## **Boggabri Coal Mine Modification 8 Amendment**

### **Updated Surface Water Assessment**

17 November 2022

Appendix A: Response to Comments

Job Number: N4002\_003

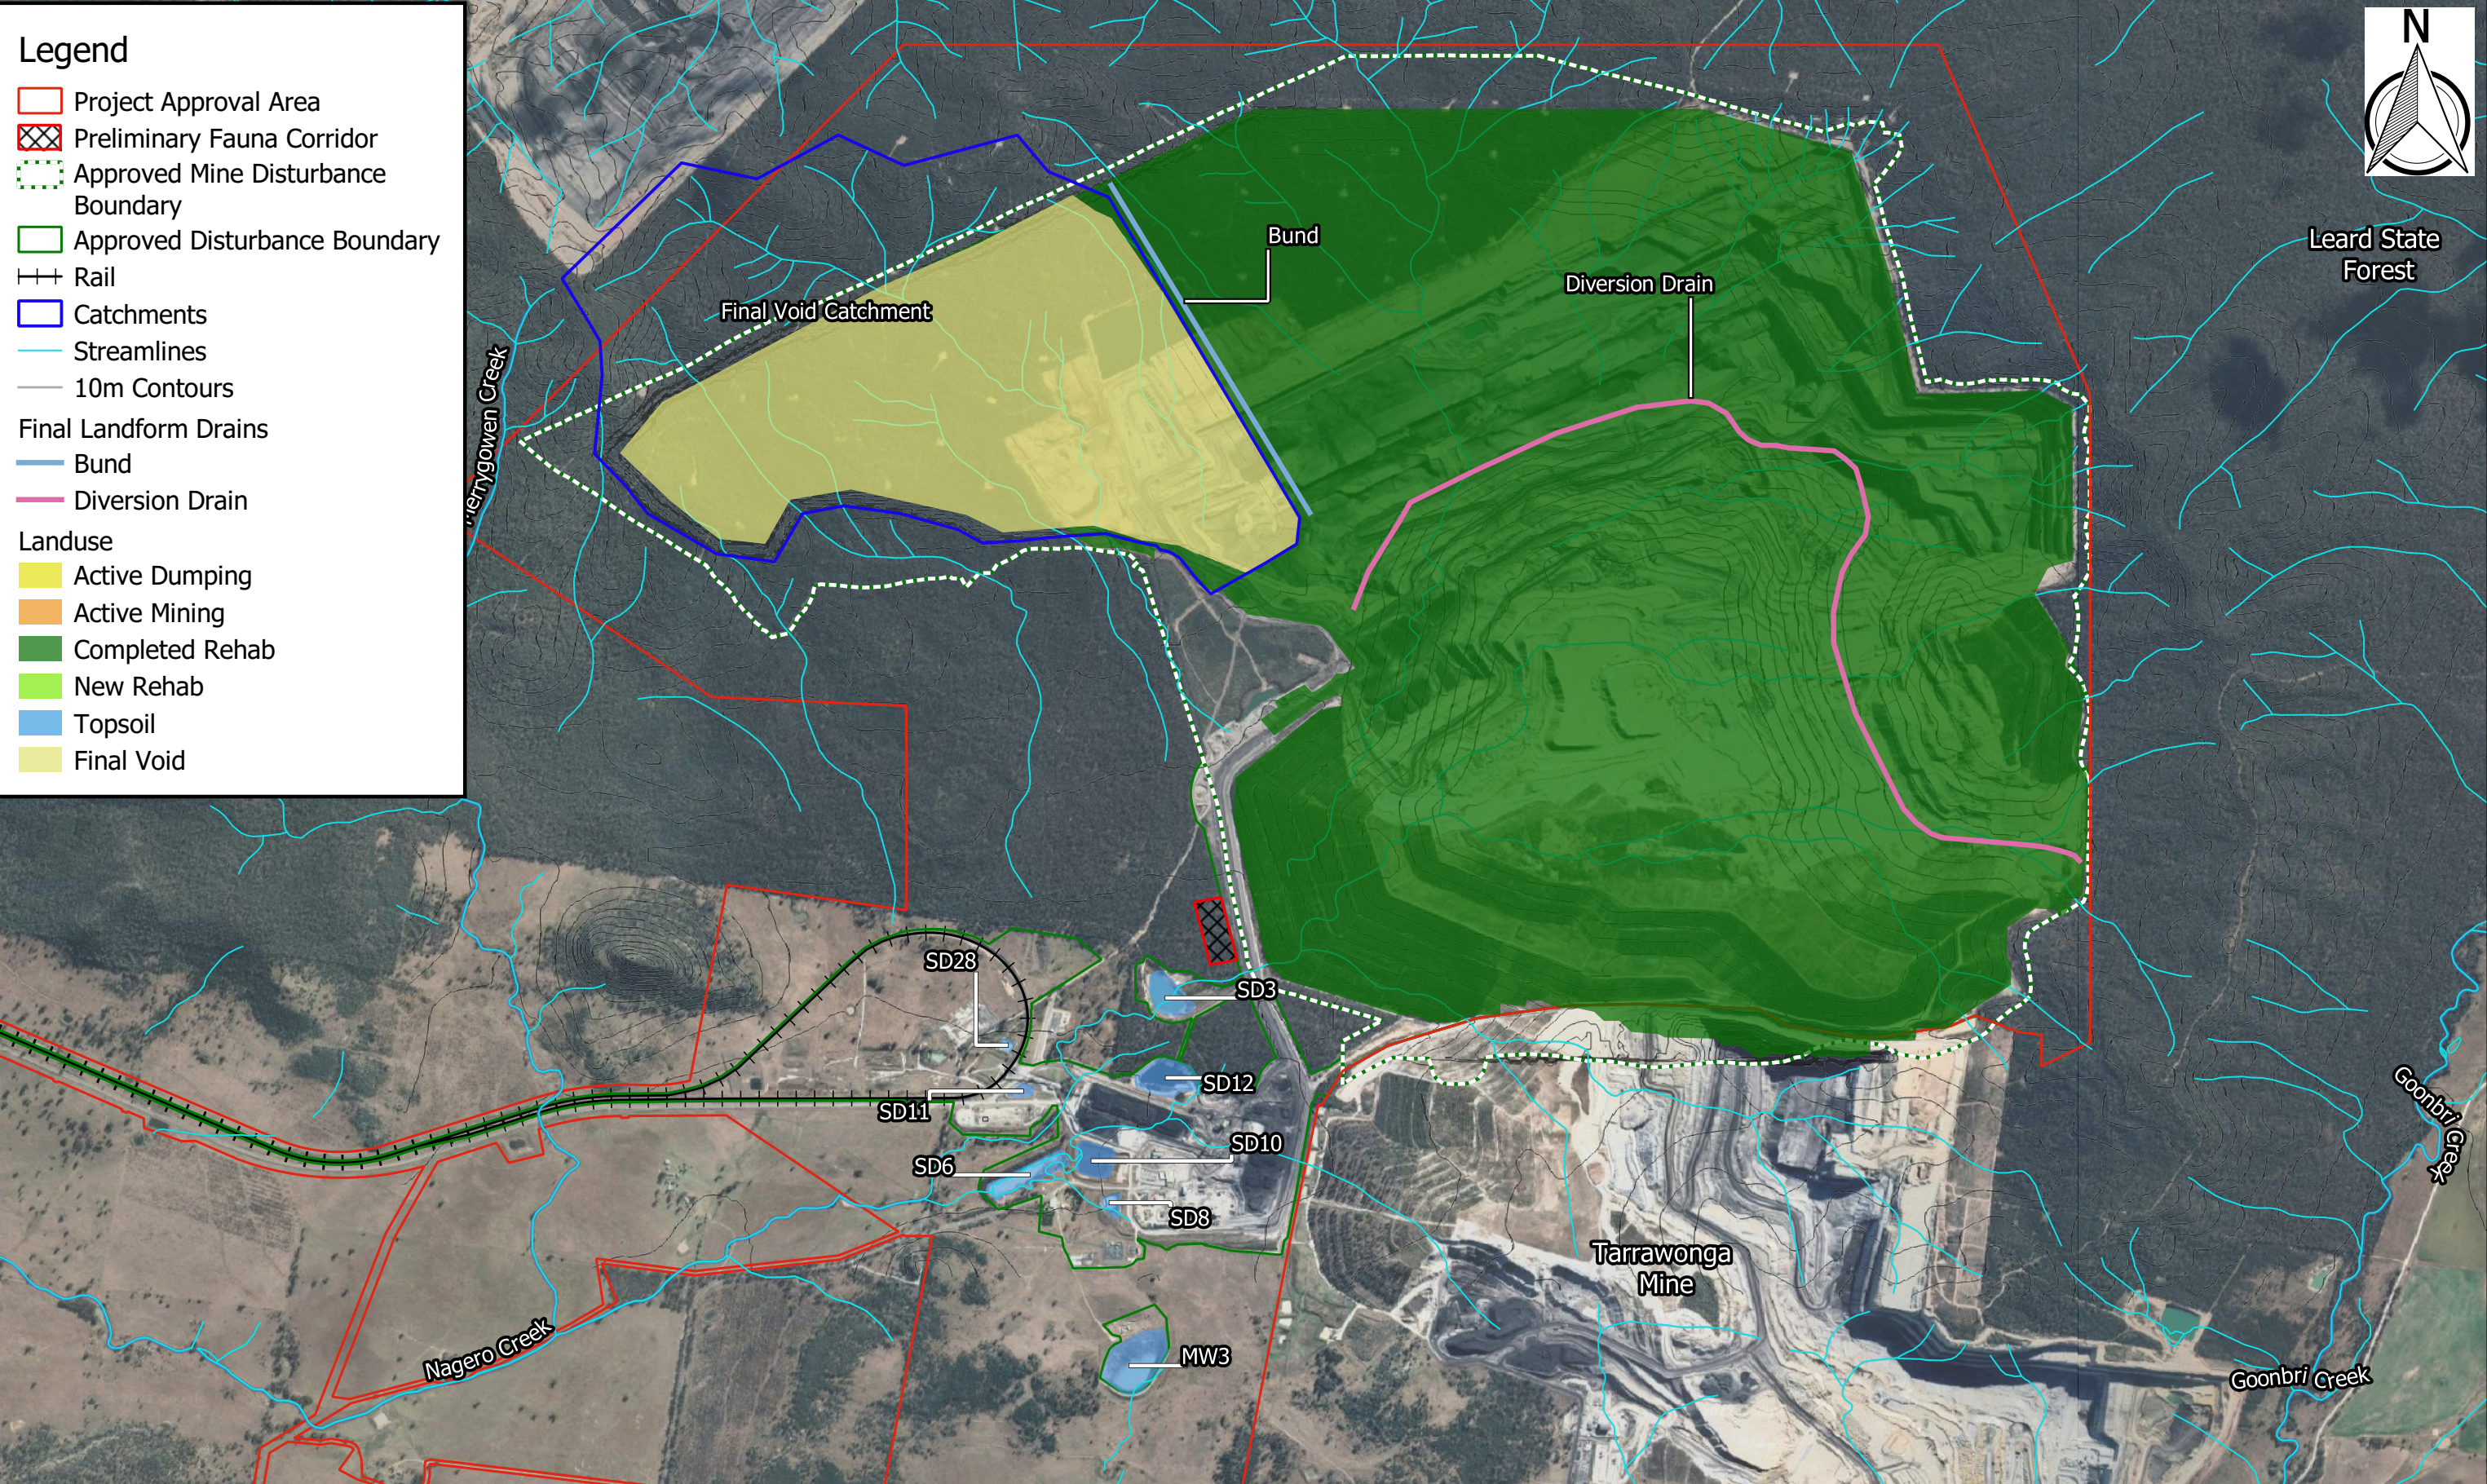
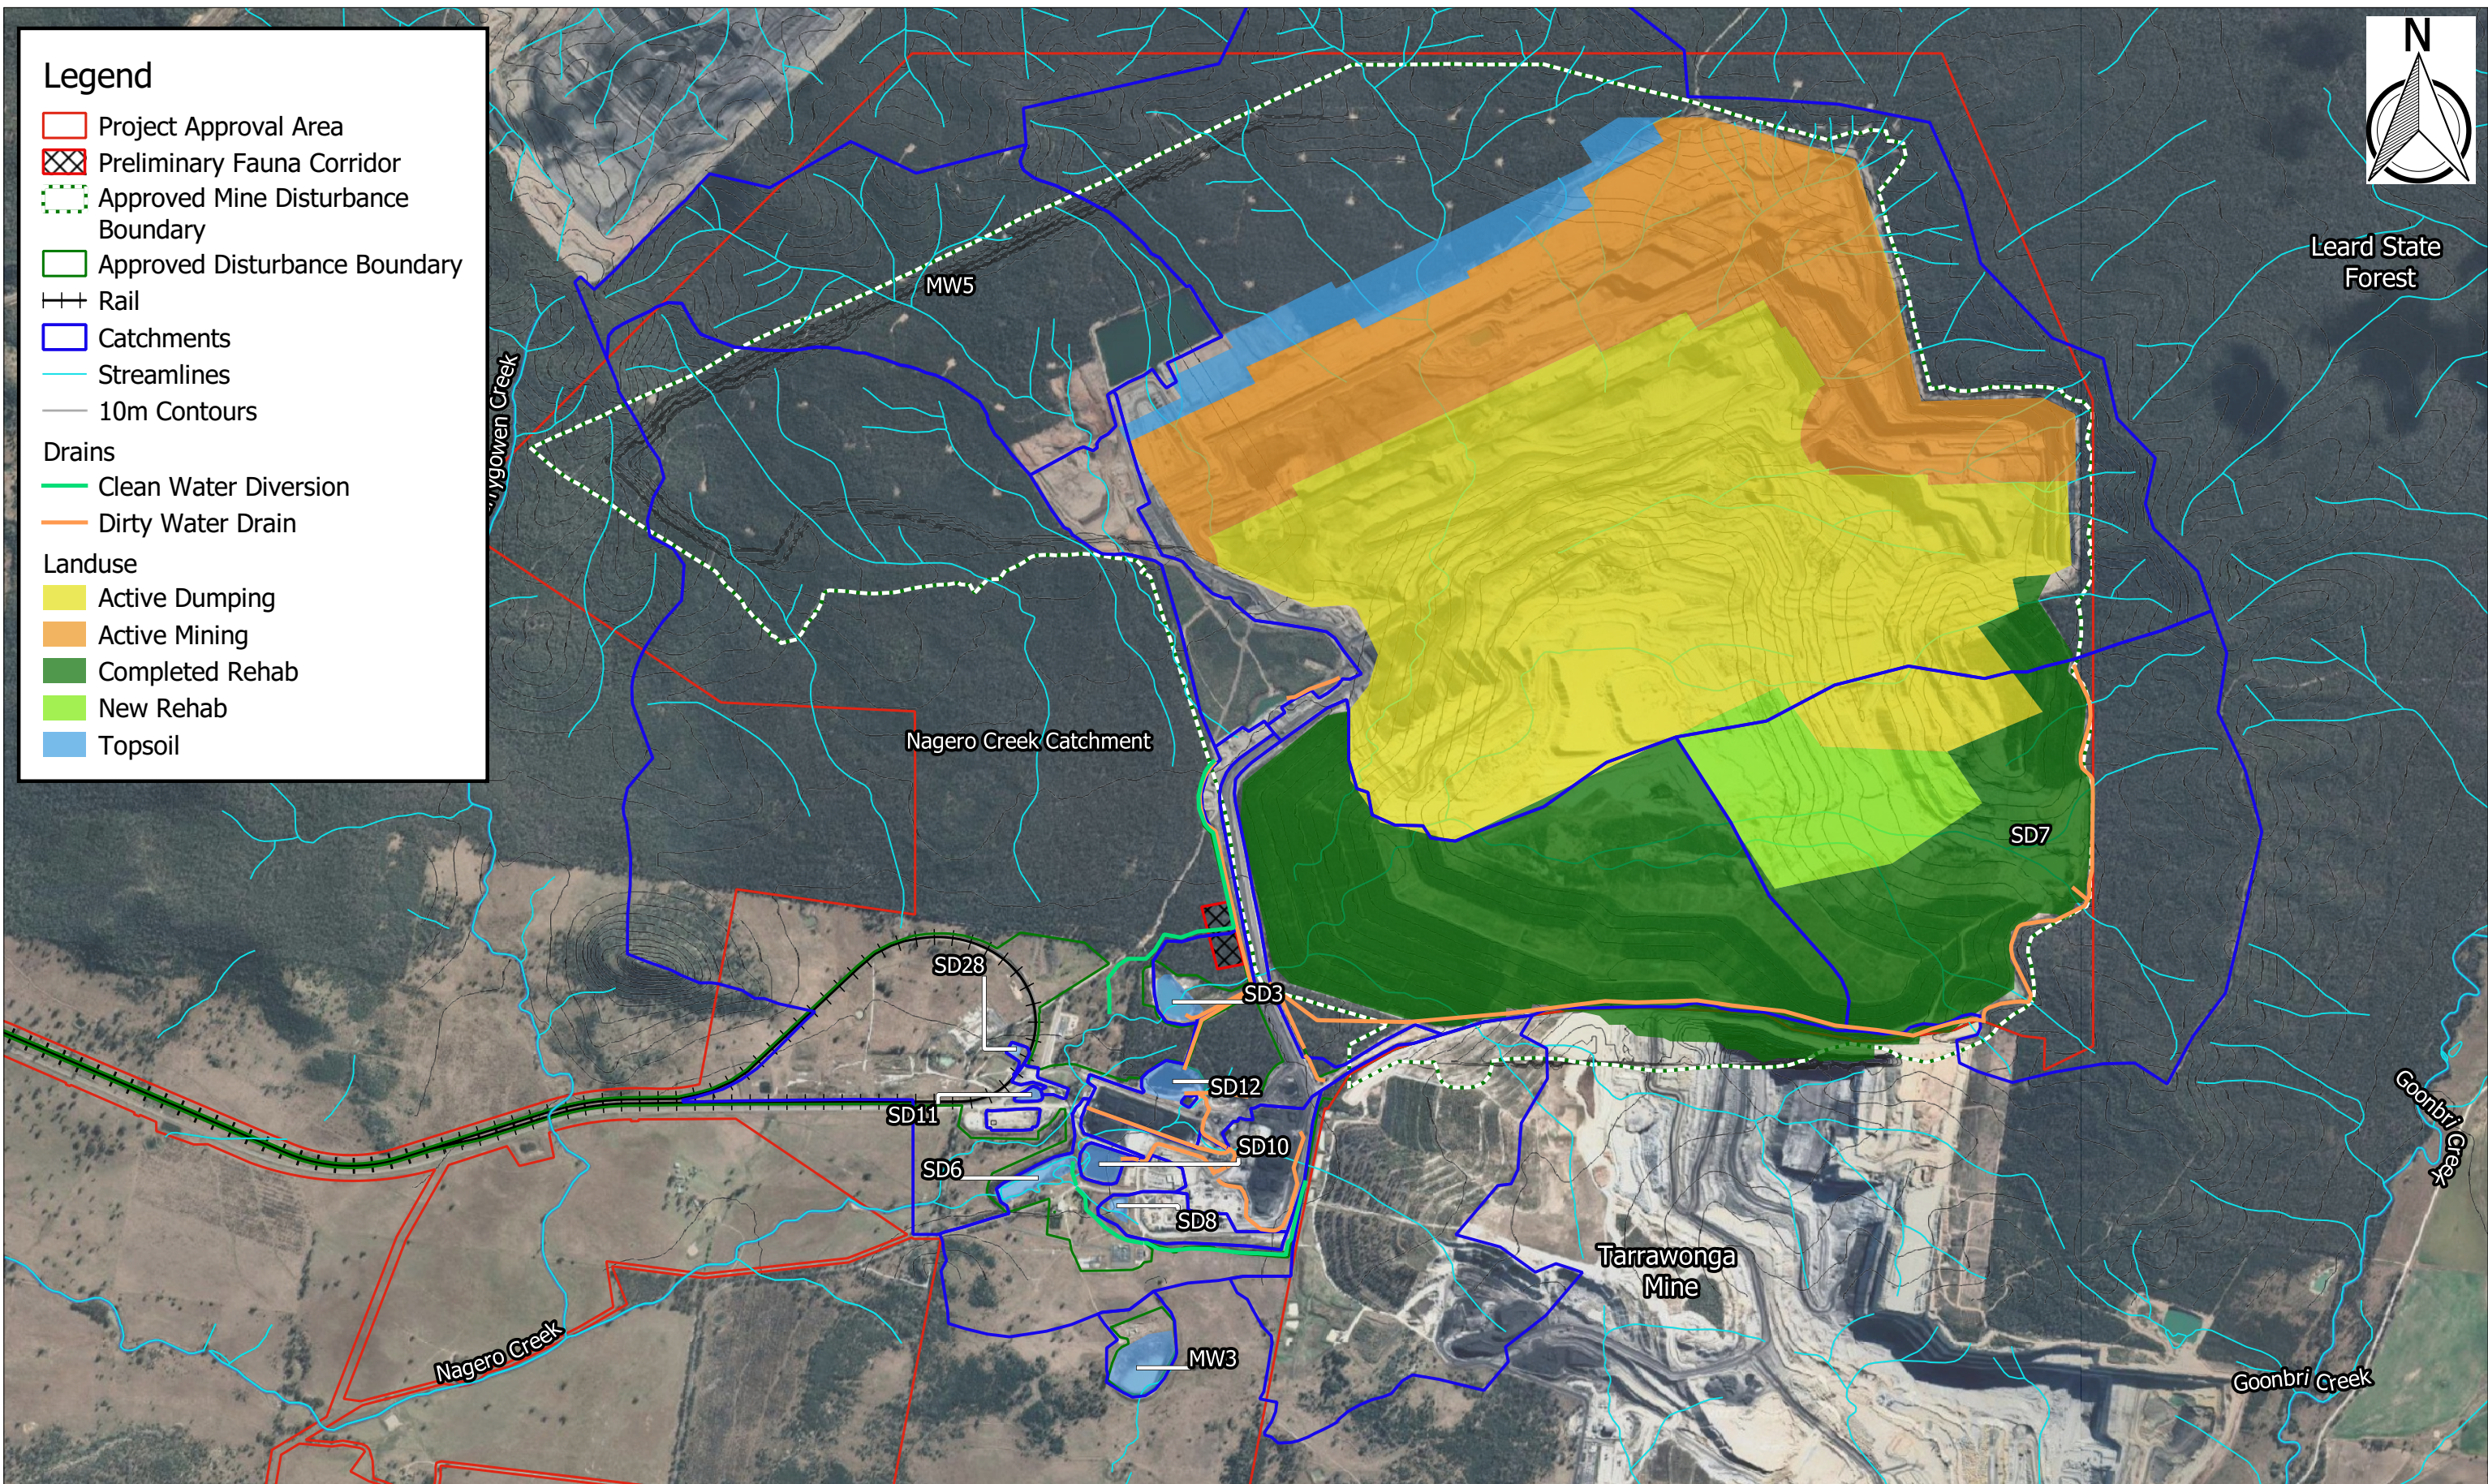
| Comment                                                                                                                                                                                                                                                                                                                                                                                                                                                                                                                                                                                                                                                                                         | Response                                                                                                                                                                                                                                                                                                   |
|-------------------------------------------------------------------------------------------------------------------------------------------------------------------------------------------------------------------------------------------------------------------------------------------------------------------------------------------------------------------------------------------------------------------------------------------------------------------------------------------------------------------------------------------------------------------------------------------------------------------------------------------------------------------------------------------------|------------------------------------------------------------------------------------------------------------------------------------------------------------------------------------------------------------------------------------------------------------------------------------------------------------|
| <p>i. The Figures 3.1-3.5 (Engeny 2021) show the clean runoff water is captured following drainage along a roadside through the coal rail line. Further information and details on how the clean water which passes this area is not contaminated by coal dust and other contaminants from runoff during wet weather events should be provided. Monitoring of the water quality may be required to provide assurances the water is not contaminated.</p>                                                                                                                                                                                                                                        | <p>Alternate flow path defined to match existing watercourse. Refer to Figures 3.1 to 3.4</p>                                                                                                                                                                                                              |
| <p>iii. The clean water diversion point south of the rail line appears to drain into a paddock. The proponent should provide information on this site in a sediment and erosion management plan, which provides assurances there is no runoff or erosion occurring during rainfall events.</p>                                                                                                                                                                                                                                                                                                                                                                                                  | <p>Alternate flow path defined to match existing watercourse. Does not discharge into paddock. Refer to Figures 3.1 to 3.4.</p>                                                                                                                                                                            |
